# Electrical Snags & Repairs

62 Whiteheart Lane  
Gerry Adams

**Assigned to:** Karen Gilbert  
**Asset:** Wall socket  
**Condition:** Burnt and not usable

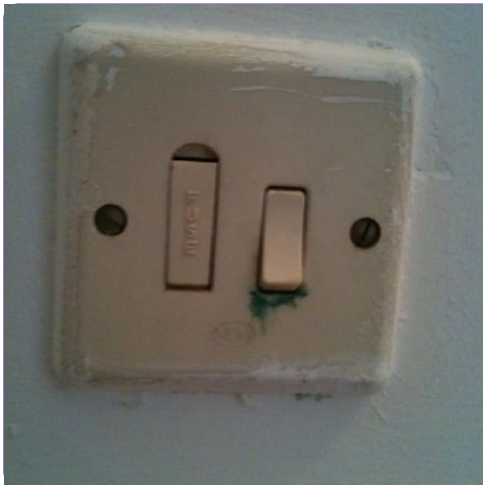
Burnt socket due to possible overload. Investigation is needed to find the root cause. Needs replacement and wiring insulation to be checked again.
